**AMENDMENT #8 TO:  
CONNERTON VILLAGE II - DESIGN REGULATION  
DATED: OCTOBER 25, 2006**

**REVISION DATE: November 15, 2013**

**REVISED September 20, 2018 - TO INCLUDE PARCEL 218**

***6.12 PVC Fencing for Parcel 211, 212, 213 and 218: Chapter 2, Section 2.10, Item number 8 “Fencing” will no longer apply to Parcel 211, 212, 213 or 218. It is replaced with the following:***

EXHIBIT "A" TO AMENDMENT #8  
PARCEL 211, 212, 213 AND 218 ONLY

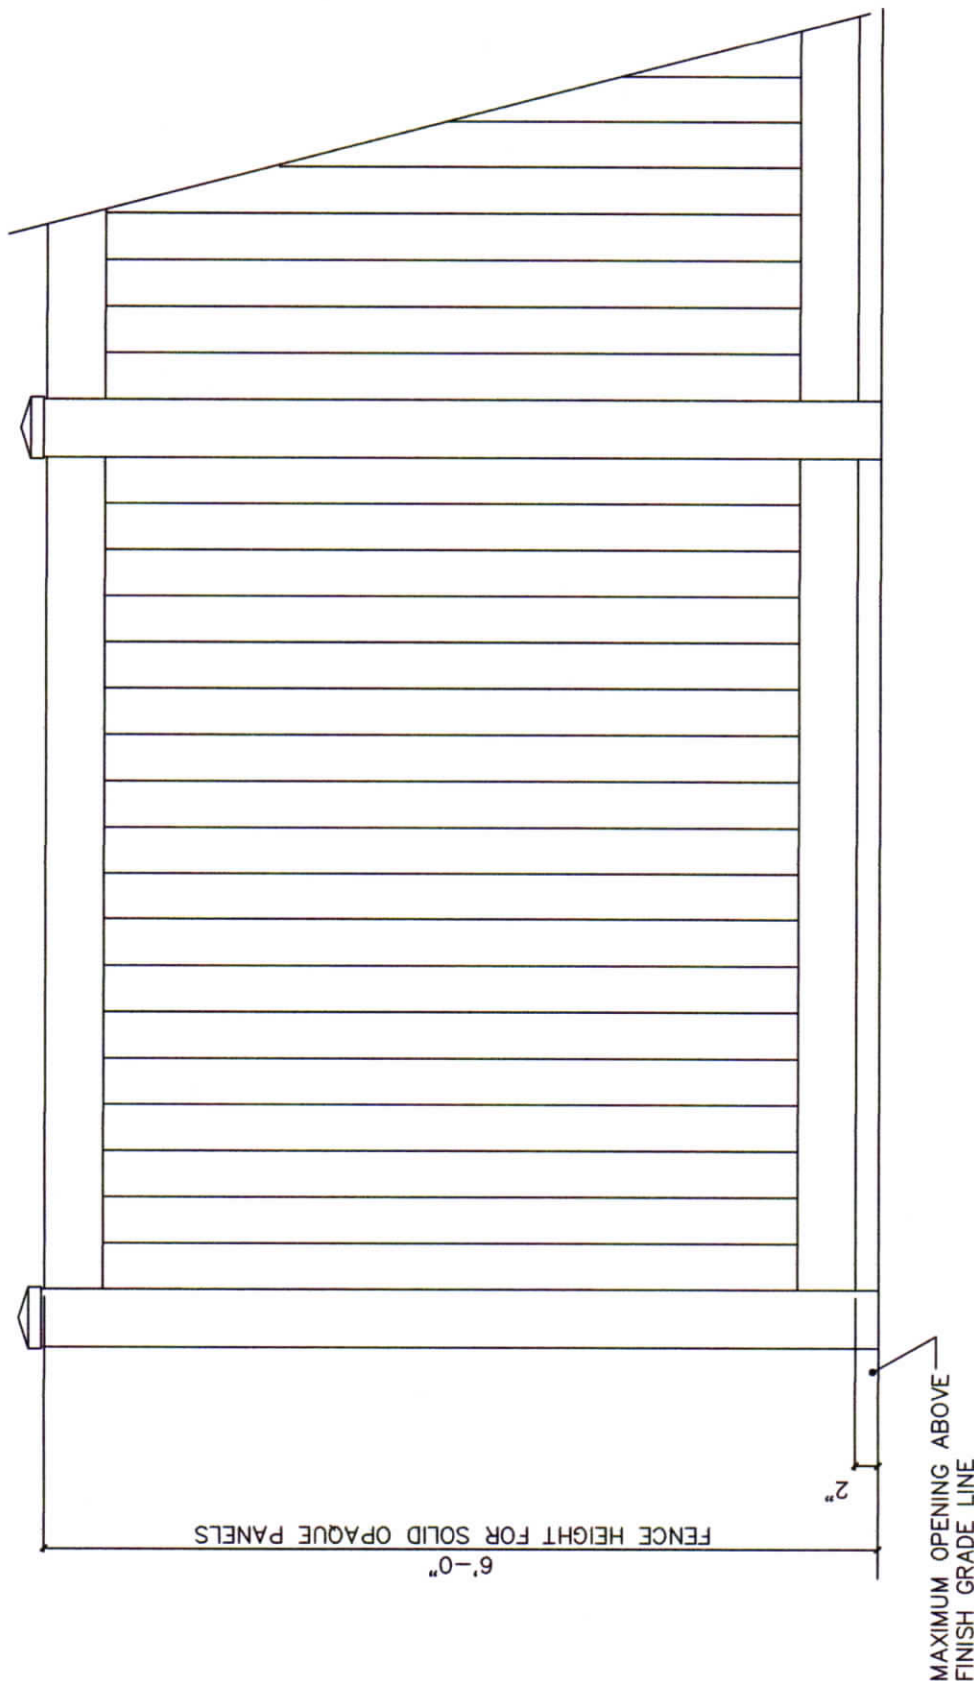
2. On Standard, Non-Conservation, Non-Amenity Lots, 6’ high solid PVC fencing as specified at Exhibit “A” of this amendment can be installed along rear and side property lines as described herein and as depicted at the site plan layout shown at Exhibit “E” of this amendment. Front Fencing, “closer” panels and gates are to be placed a minimum of 10’ (ten feet) back from the front corners of the house structure exclusive of the front porch. Gates are to match the design of the fence panels (i.e. no arched panels or decorative top-rail designs).

EXHIBIT "B" TO AMENDMENT #8  
PARCEL 211, 212,213 AND 218 ONLY

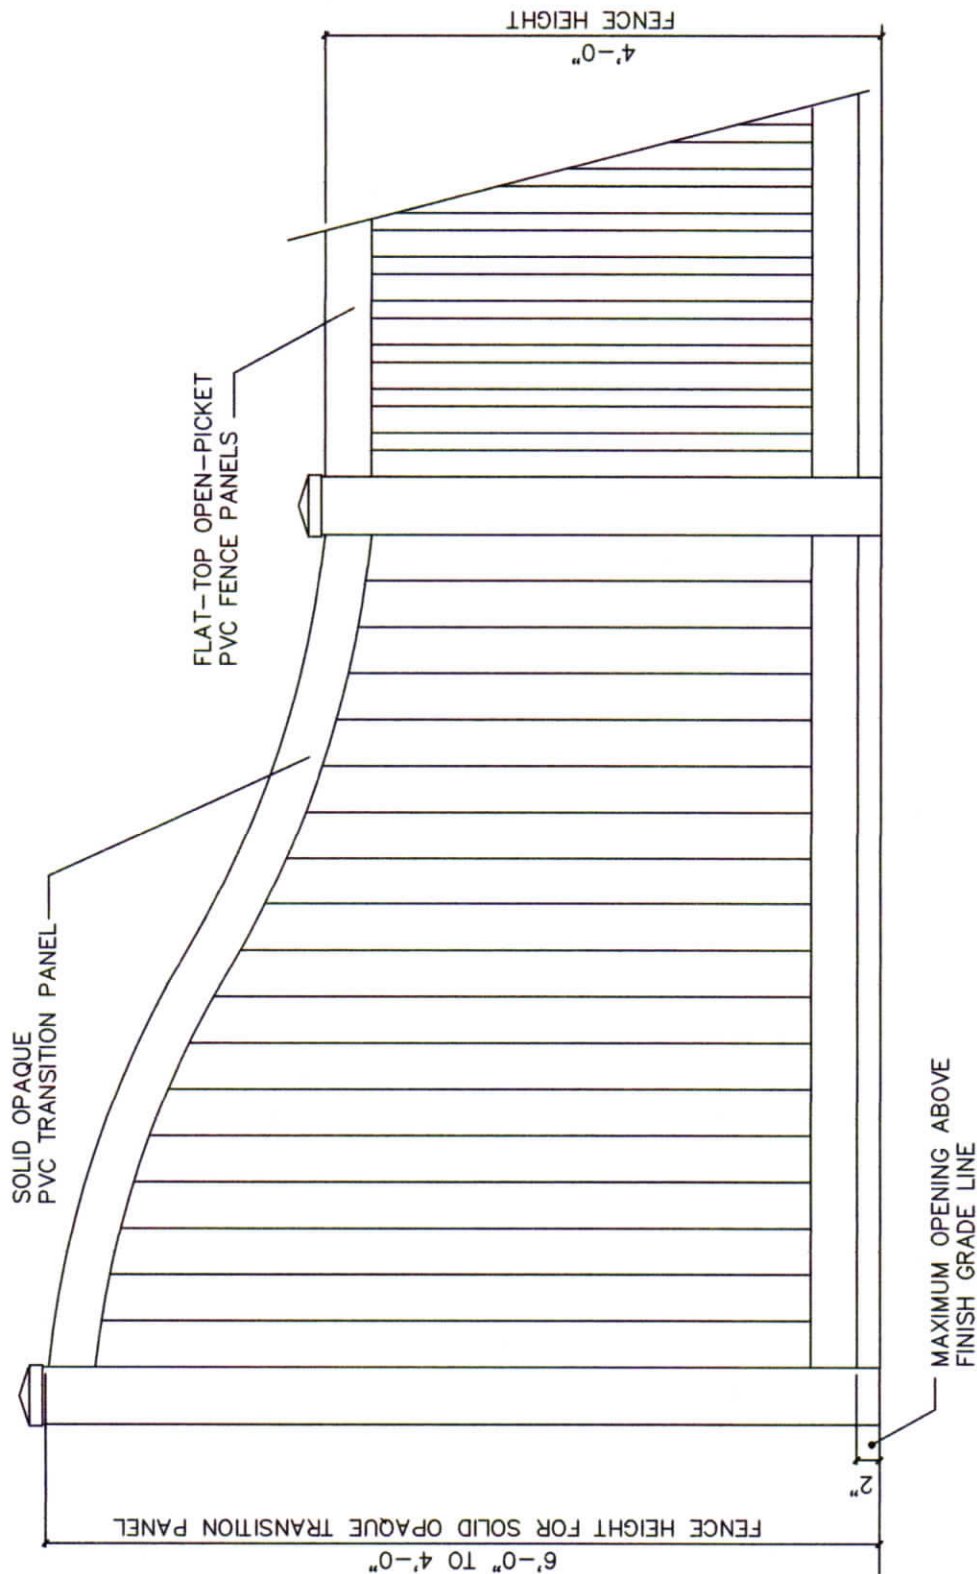
3. On Conservation Lots, a combination of 6’ high fence panels, transition panels, and 4’ high flat-top open picket panels, as specified at Exhibits “A”, “B” and “C” respectively, shall be installed as depicted at Exhibit “D”

# EXHIBIT "F" TO AMENDMENT #8

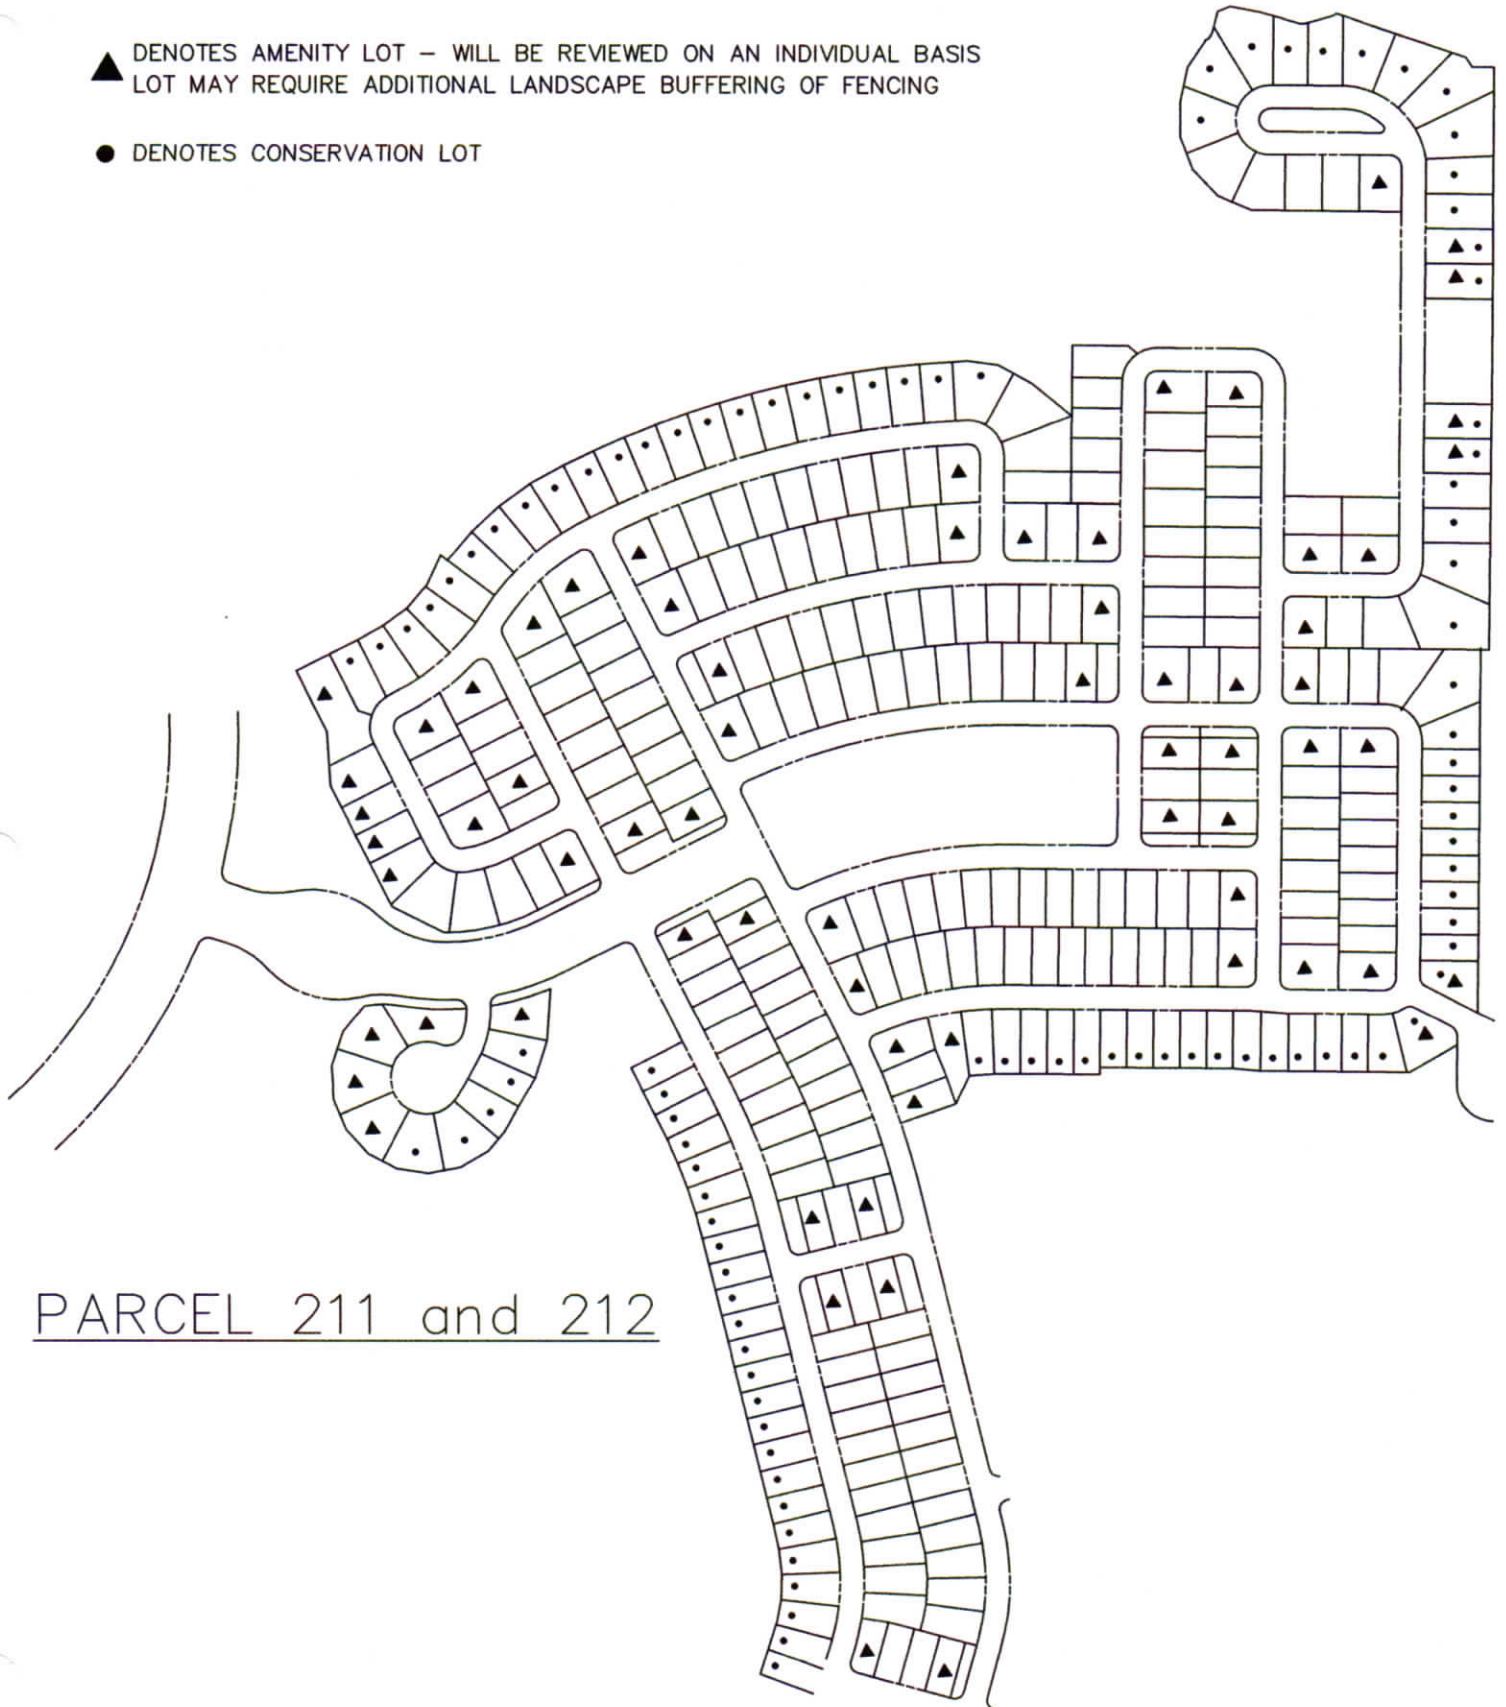
2. Refer to Exhibit “F” of this amendment “Fencing Control Map” for Parcel 211 for individual site designations as to “Standard”, “Conservation” and “Amenity” lots.

4. Amenity Lots will be reviewed on an individual basis. Homeowners may be required to install additional landscape buffering of the fencing. Fence configurations may be required to use any of the (3) types of panels as directed by the Connerton Design Review Board.
